Status Report No. 2, Retrofit Pilot Program, Caltrans Districts 7 & 11

July 14, 1998 CTSW-RT-98-099

Appendix A - NRDC Design	Comments and	Responses
--------------------------	--------------	-----------

Subject: Response to Review of District 7 Procurement Design Packages

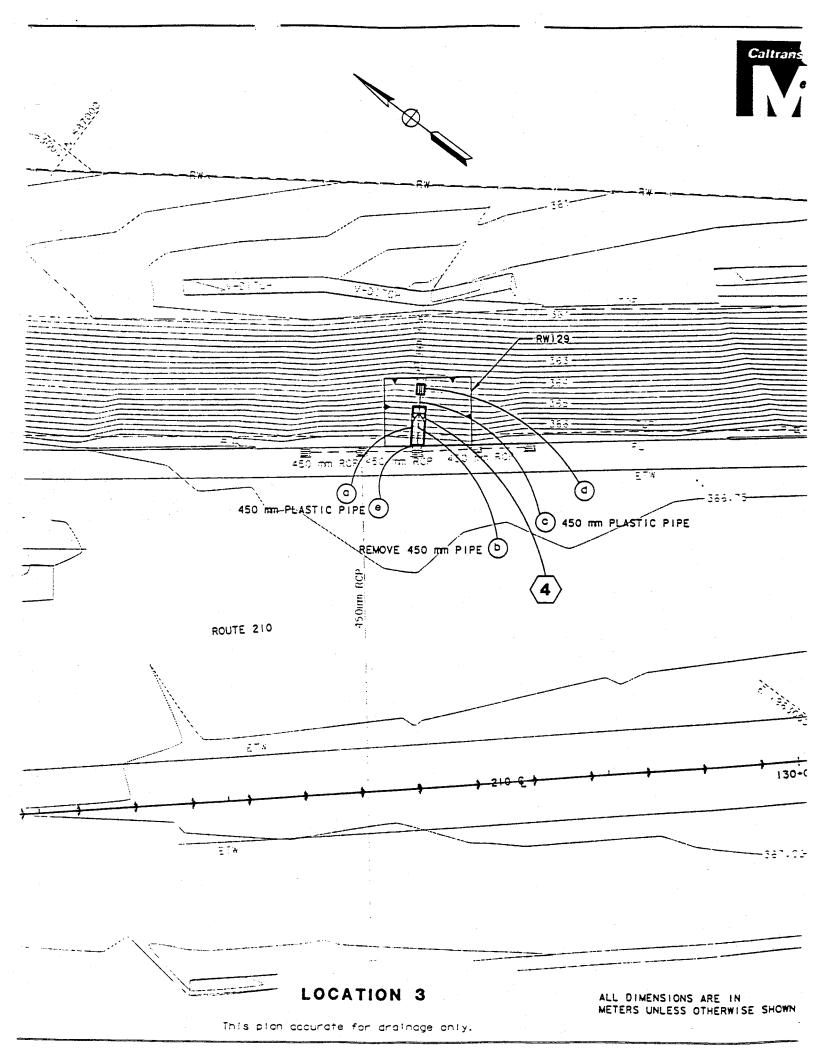
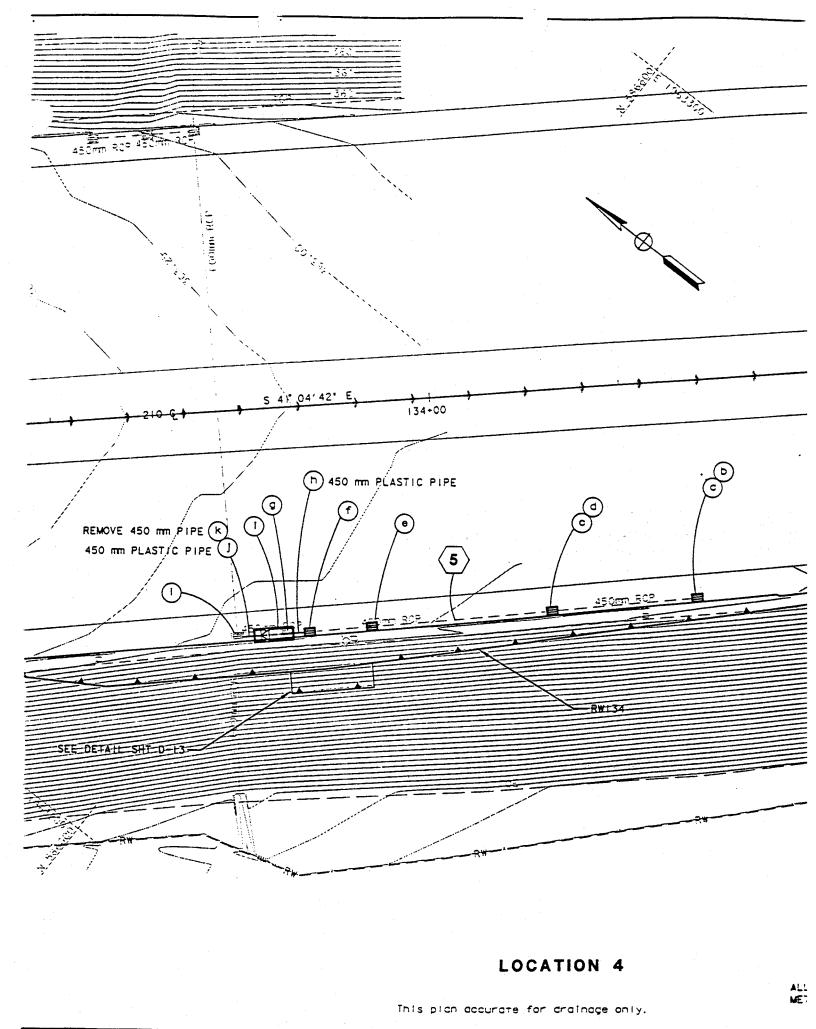
Locations 3 and 4 appear not to be equivalent, but lack of consistency and clarity in the plans clouds whether they are or not. For Location 3, plan sheet L-3 shows <u>four</u> DIs in the westbound lanes, with a single DI and a pair in series each draining to the fourth one. That same DI also takes drainage from one DI in the eastbound or connector lanes. However, the accompanying information summary, as well as the Composite Siting Report, refer to <u>five</u> westbound and one median (between connector and eastbound mainline) DI. Are there four or five westbound DIs? Also, the plan seems to indicate a pipe exiting from the connector or eastbound DI. Does that pipe exist and, if so, will it be capped or removed?

Plan sheet D-5 shows a sampling point for the three westbound TCBs in series, while D-4 indicates a sampling point following the eastbound TCB getting the total flow of the catchment. Are we reading the plans correctly? If so, what is the monitoring philosophy here?

What will happen to the inlet labeled (m) on plan sheet D-5? It is shown to be deleted but still connected to the system. It looks like some water could bypass that inlet; is that true?

Response: Location 3 does include five (5) drain inlets located along the Westbound shoulder as indicated in the Composite Siting Report and Information Summary Sheet - the layout sheet was in error and has been corrected. The pipe appearing to exit from the eastbound DI is actually flowing into the DI, and is the discharge from the DI located along the Eastbound shoulder (which is not shown on the plan). The DI shown at the bottom of the plan is the DI located on the median. A layout is attached to clarify this arrangement.

Response: The monitoring scheme on the Eastbound shoulder does function as you have described. However, the monitoring on the Westbound shoulder takes place upstream of the DI which receives the flow from the Westbound side, and therefore only monitors the performance of the Eastbound retrofitted TCBs.

Response: The drain inlet labeled (m) will be sealed to prevent runoff from entering it from the roadway. However, it will not be removed because it is necessary to conduct the runoff from the Westbound side to the Eastbound side.

LOCATION 4

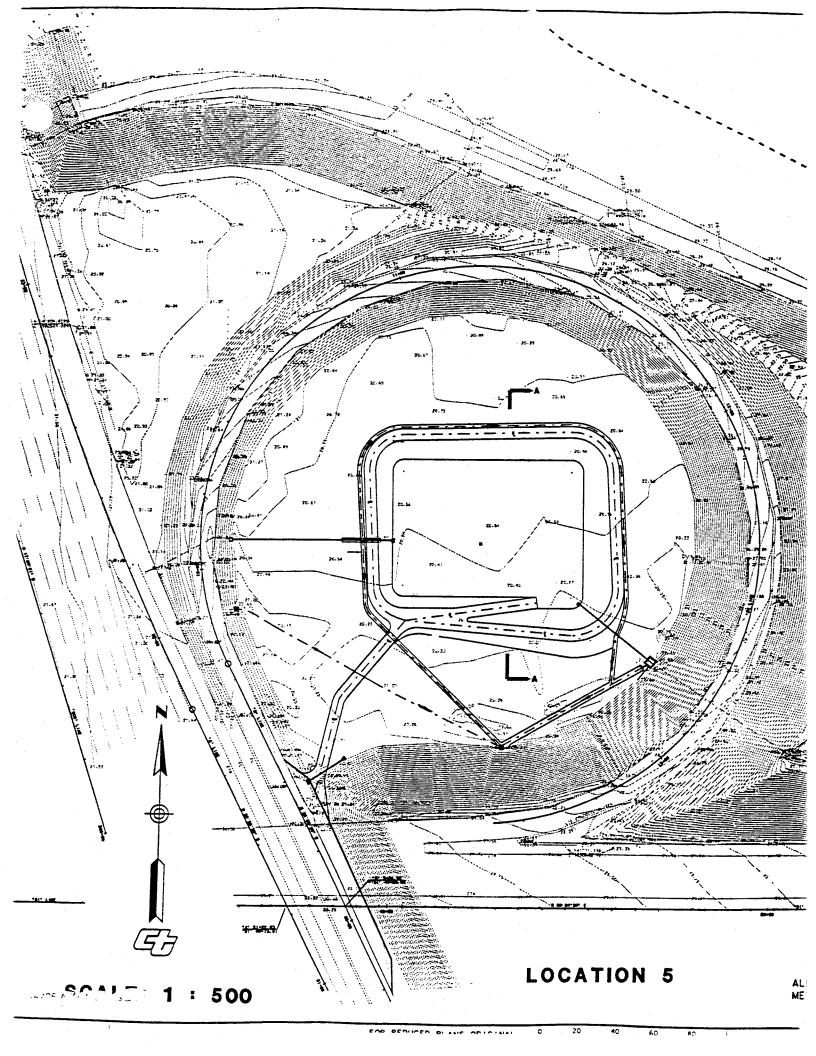
Location 4, paired as the retrofit with Location 3, appears to have two westbound TCBs draining into a third, which discharges to a TCB in the eastbound lanes. That TCB also seems to get flow from a series of three other TCBs in the eastbound lanes. If those impressions are correct, this one TCB takes flow from the entire 3.7 acres, which would surely compromise its solids retention performance. We have questions about other aspects of this location:

Response: The existing drainage system does operate as you have described. However, this is no different than the existing functionality of Location 3, which was originally designated as the retrofit site. In Location 3, six drain inlets eventually discharge into one DI located along the

Westbound shoulder. Therefore, designating Location 4 as the retrofit has not compromised the study. In addition, all retrofitted drain inlets will be checked every two weeks during the monitoring phase, which will provide ample opportunity to ensure that the final downstream DI will perform as designed.
